PROJECT : SA6
Quanta Computer Inc.

| Size: Custom | Document Number: CLOCK GENERATOR | Rev: 5B |

A-test to B-test EC list

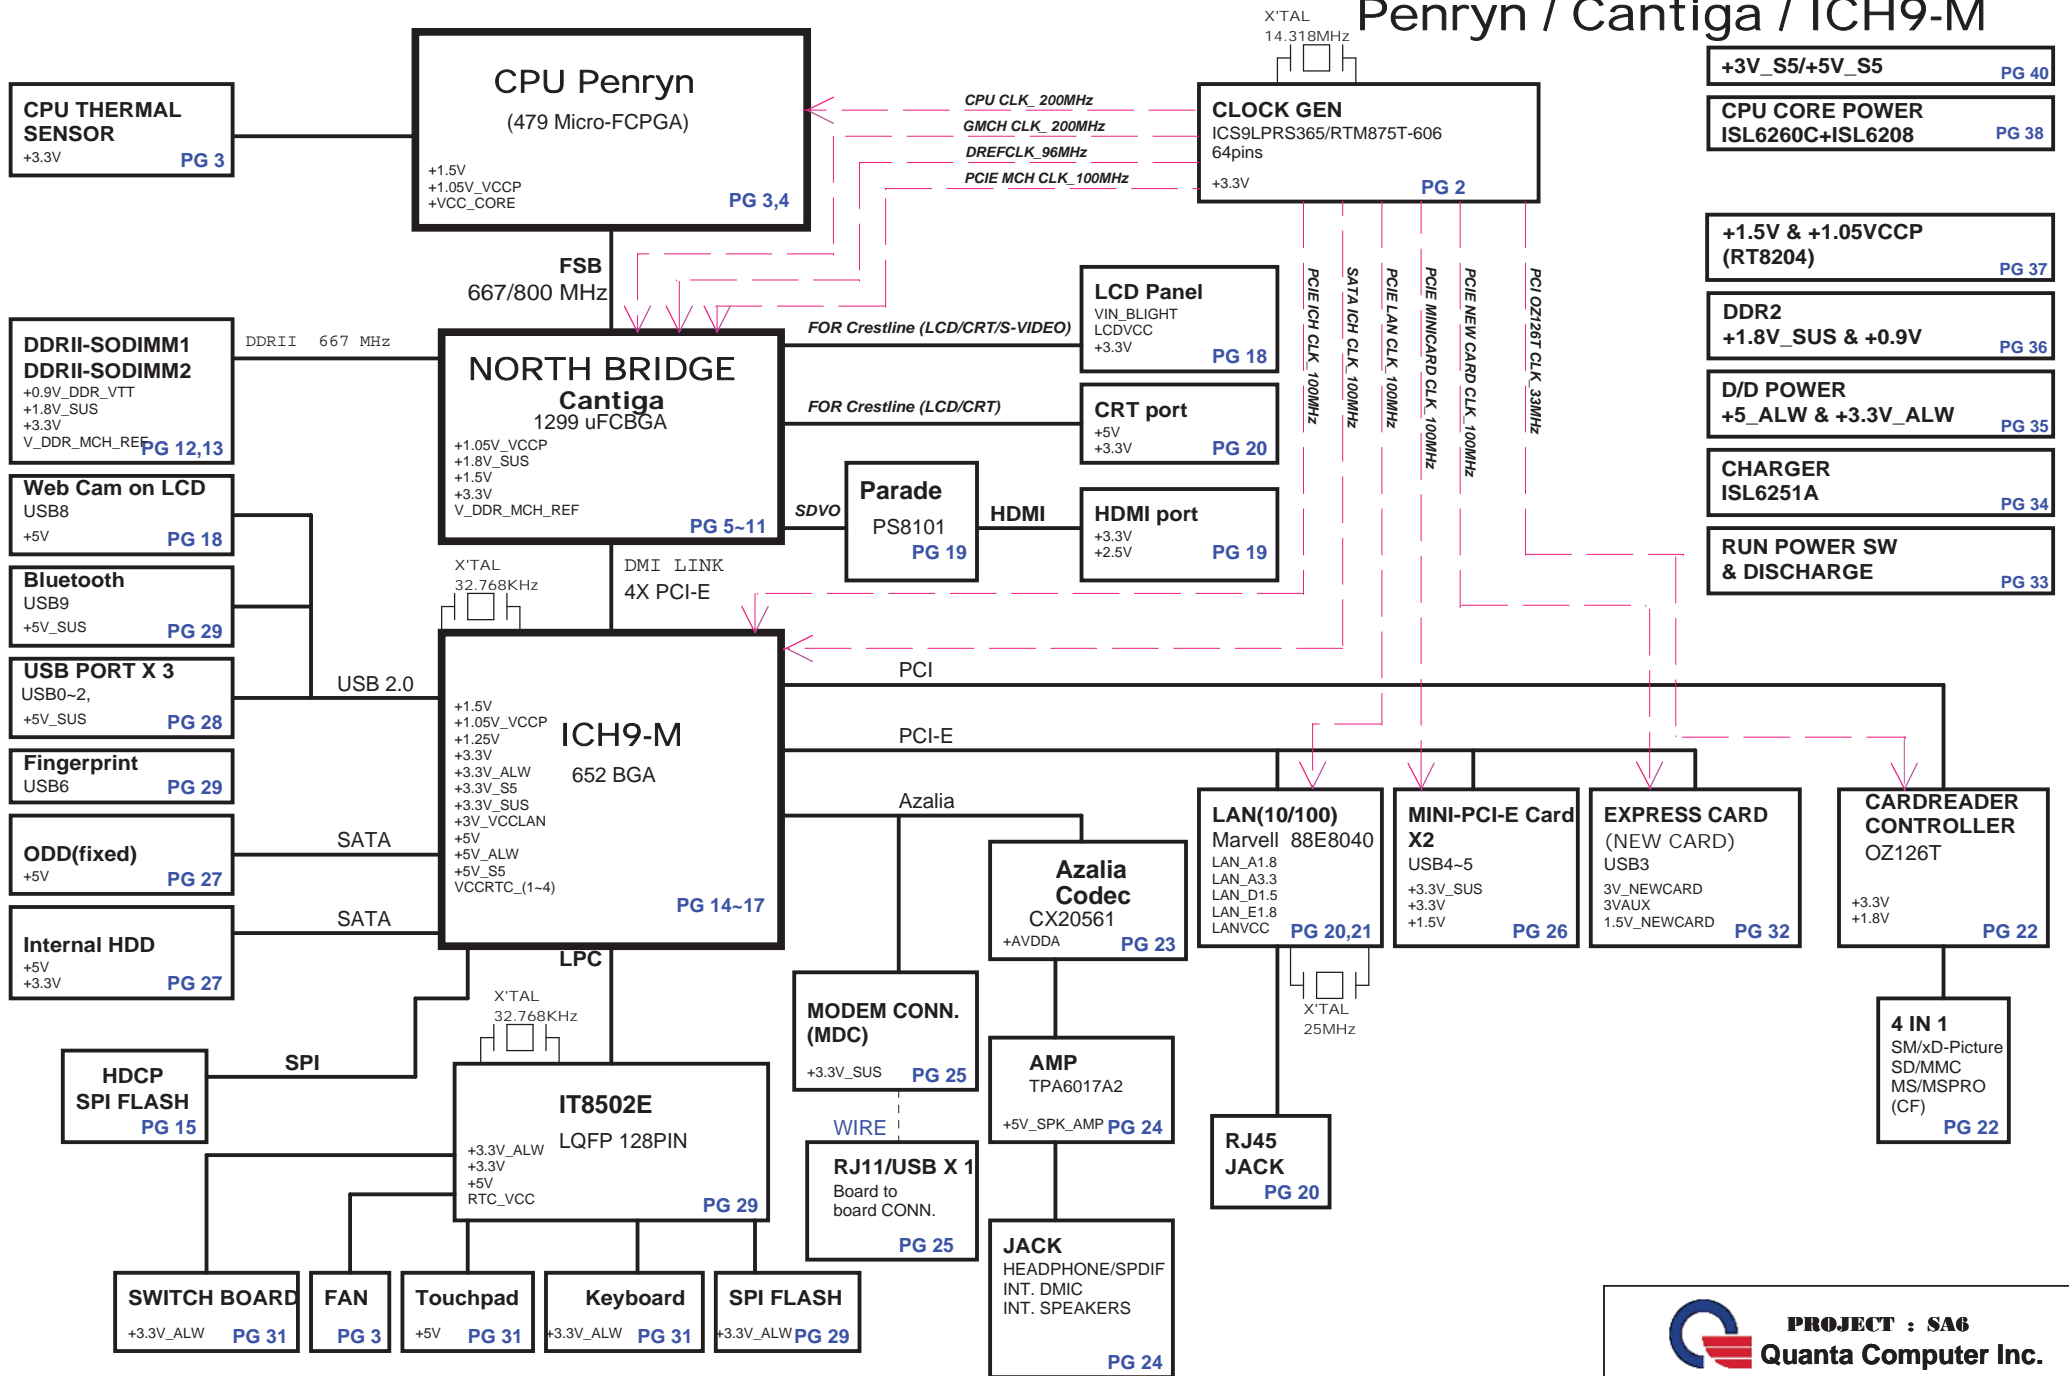
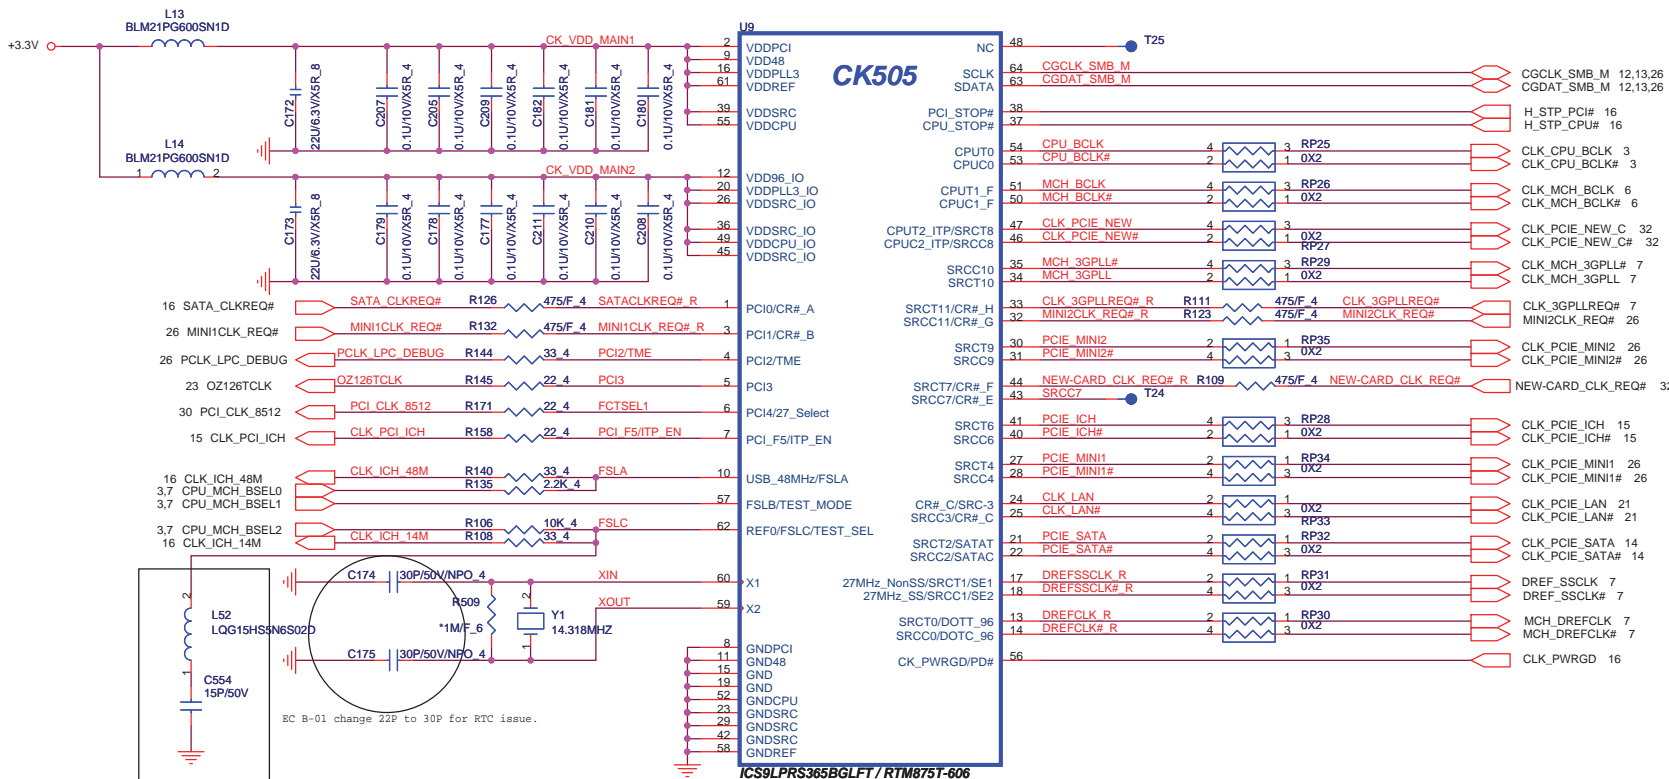
EC C-10/03 Change C229 to 10P and R171 to 22 ohm for meet Clock test.

| Size Custom | Document Number LVDS/LCD CONN/LID/WEB CAM | Rev 3B |

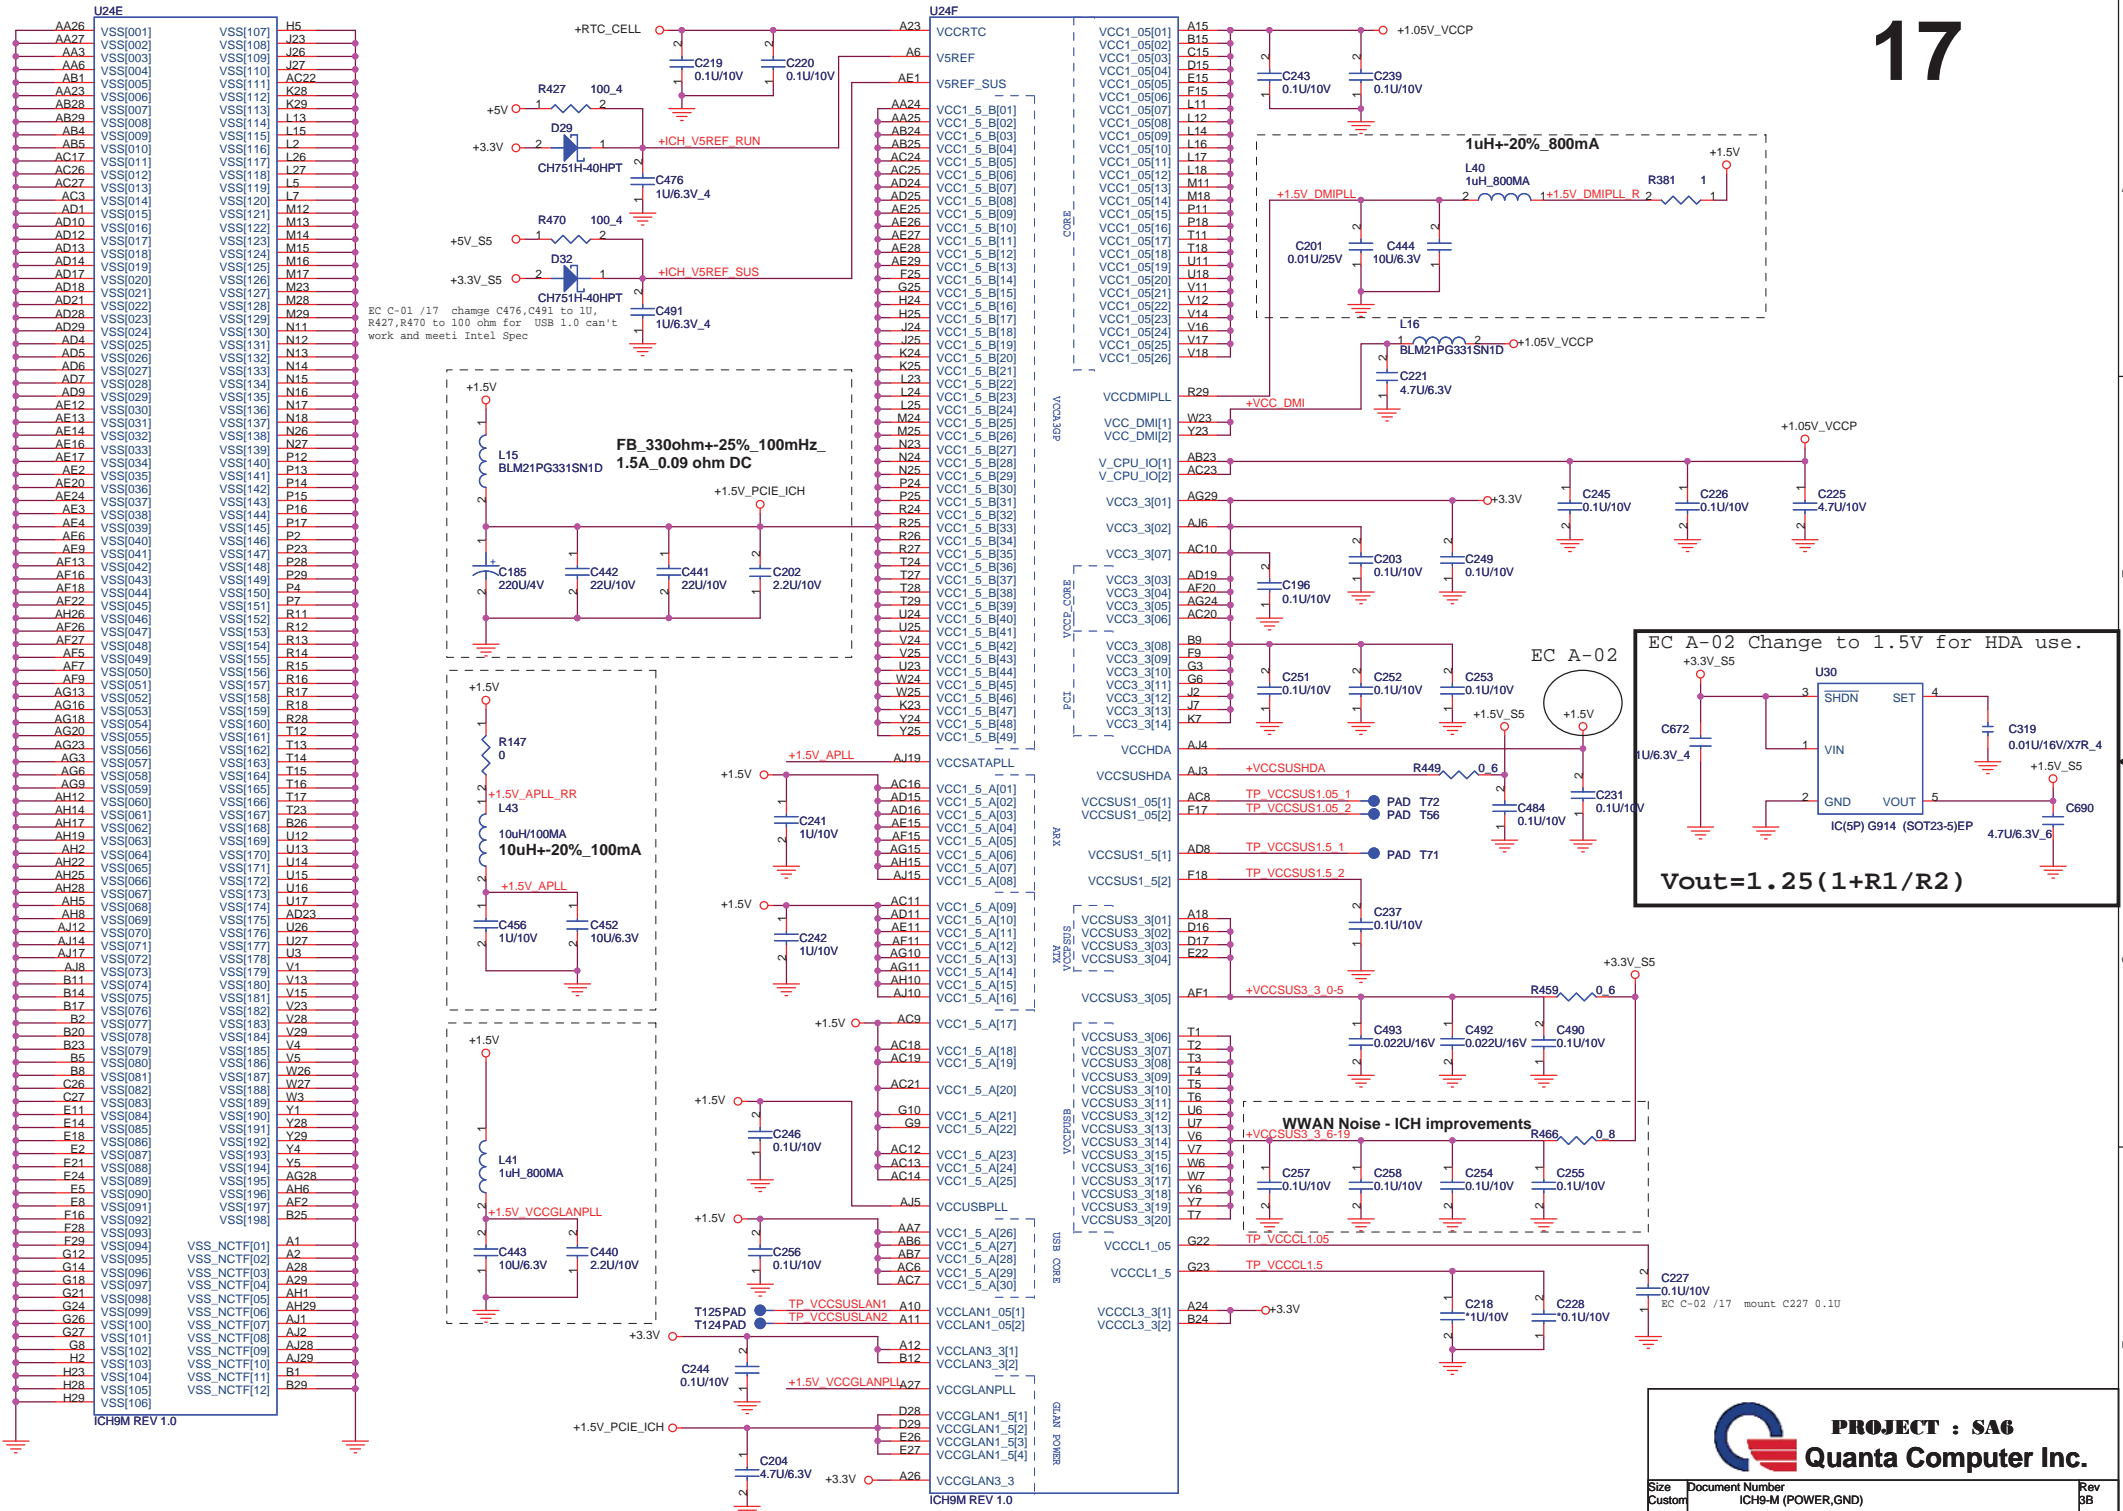
EC C-01 /17 change C476,C491 to 1uH, R427,R470 to 100 ohm for USB 1.0 can't work and meet Intel Spec

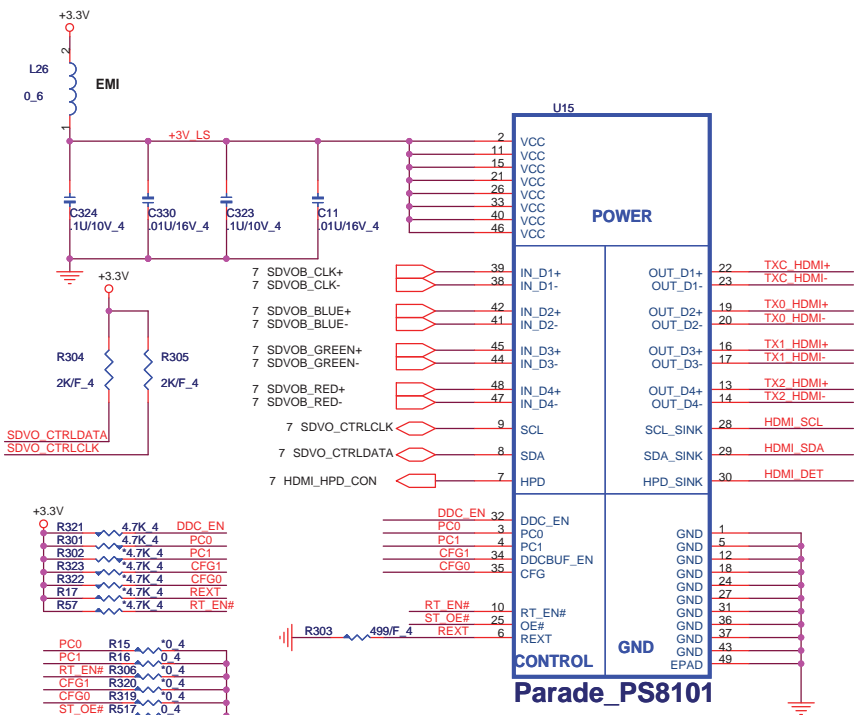
EC C-05 /19 change Pin 25 connect to GND.

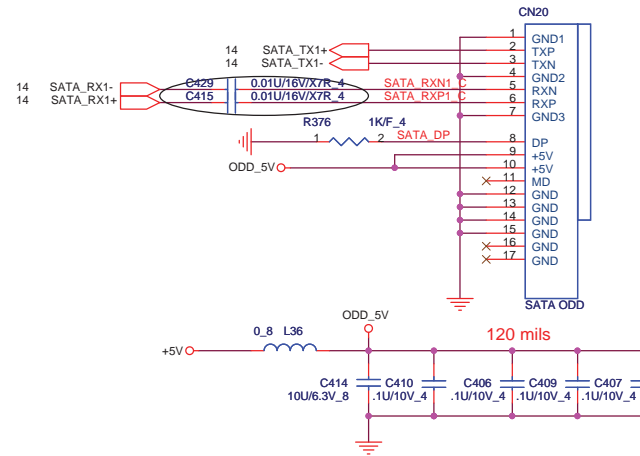
EC C-06 /27 change C479,C481,C415,C429 to 0.01U for meet Intel Spc.

| Custion | Doc = KBC-IT8502 | BB |

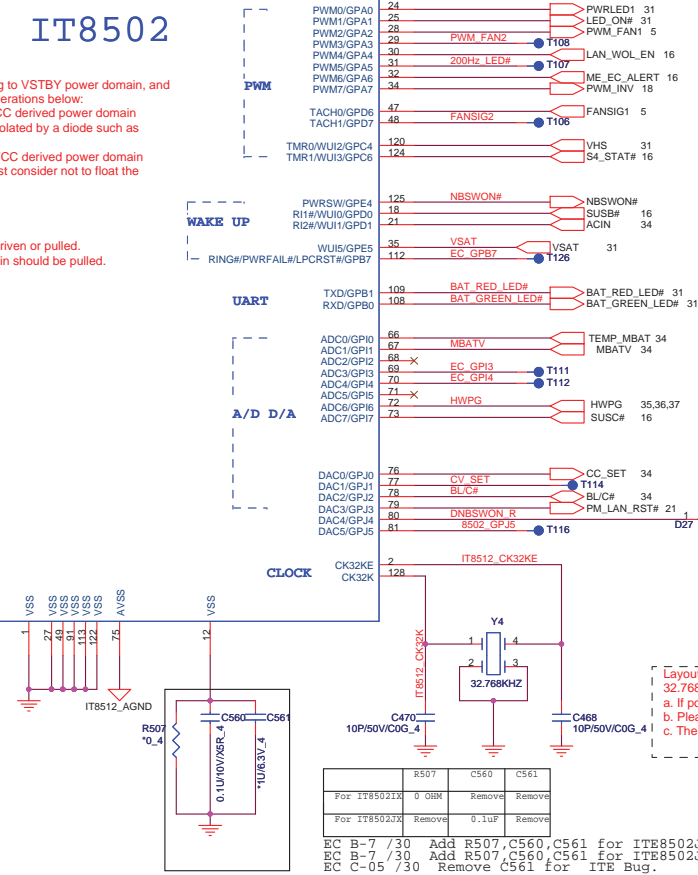
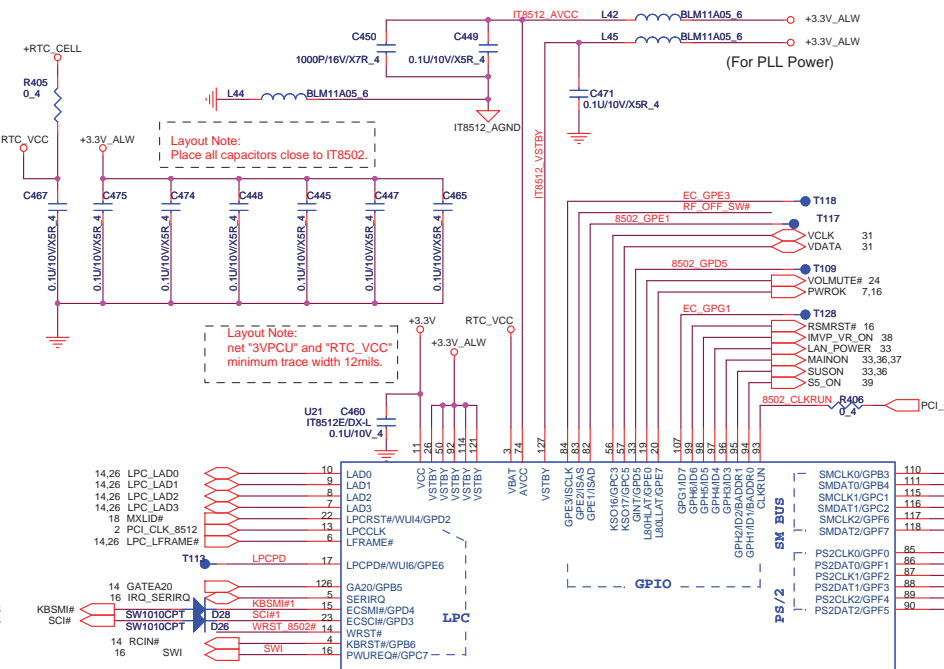
EC B-7 /30 Add R507,C560,C561 for ITE8502JX use.
EC B-7 /30 Add R507,C560,C561 for ITE8502JX use.
EC C-05 /30 Remove C561 for ITE Bug.

| Custom | D/D POWER | 3B |

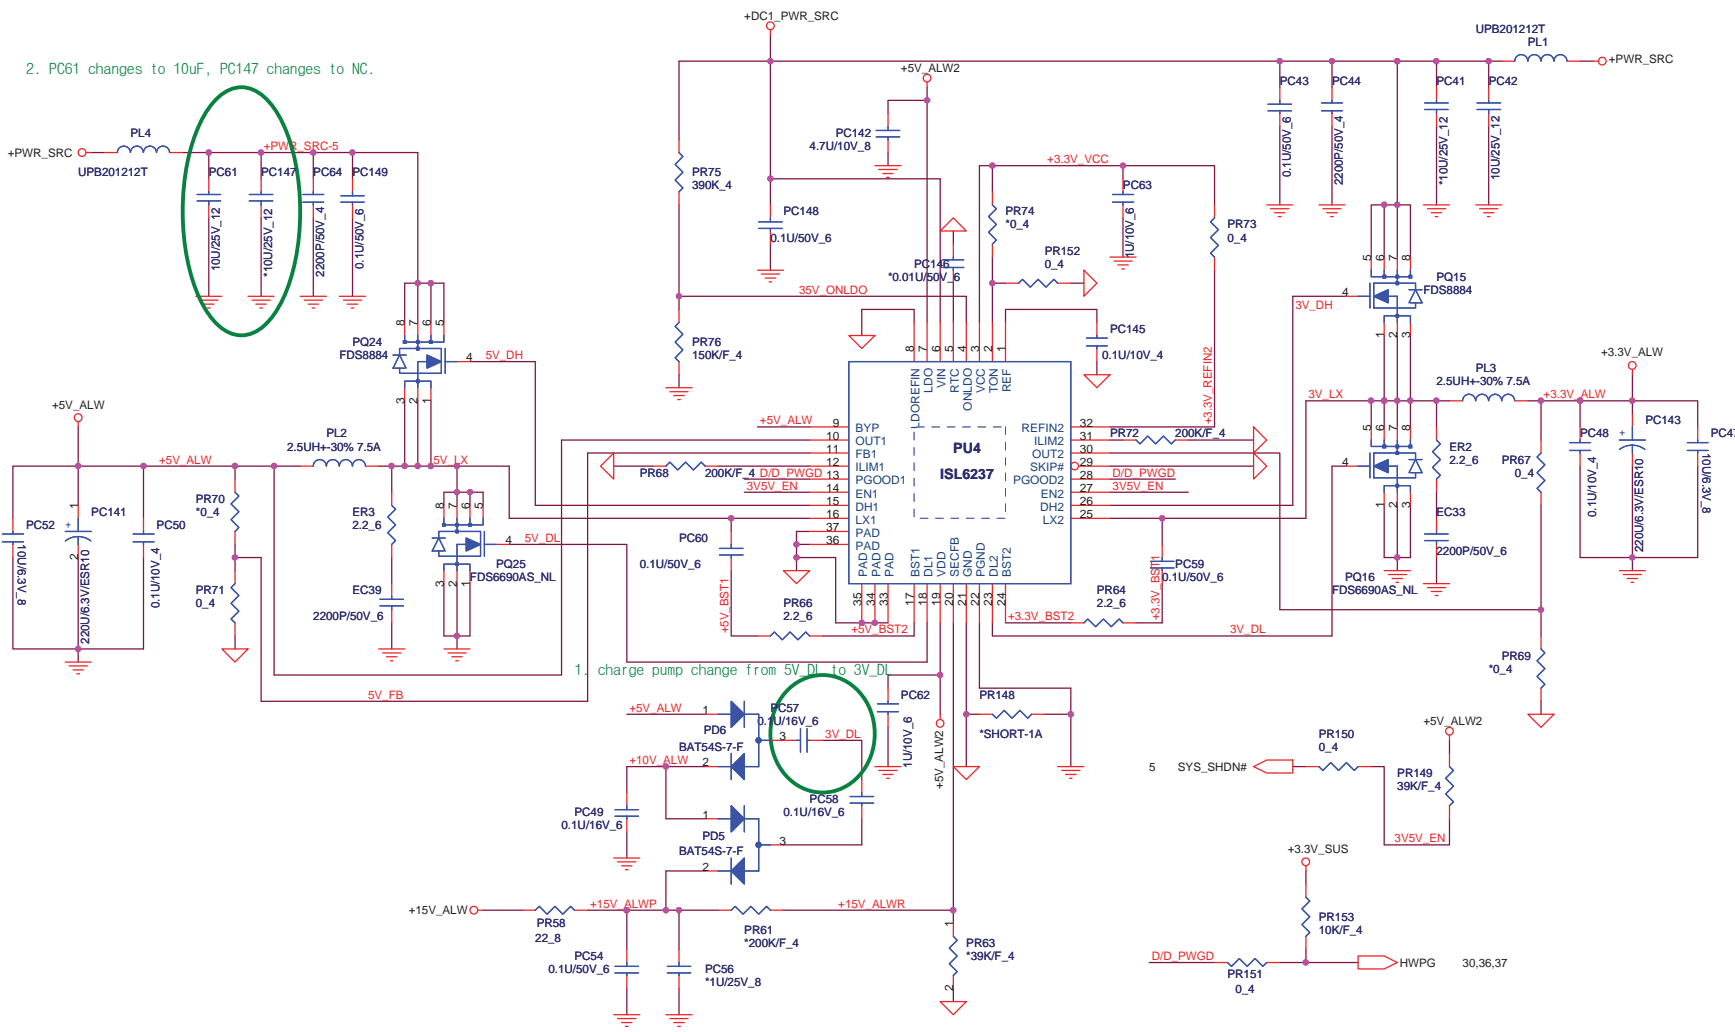
2. PC61 changes to 10uF, PC147 changes to NC.

1. charge pump change from 5V DL to 3V DL
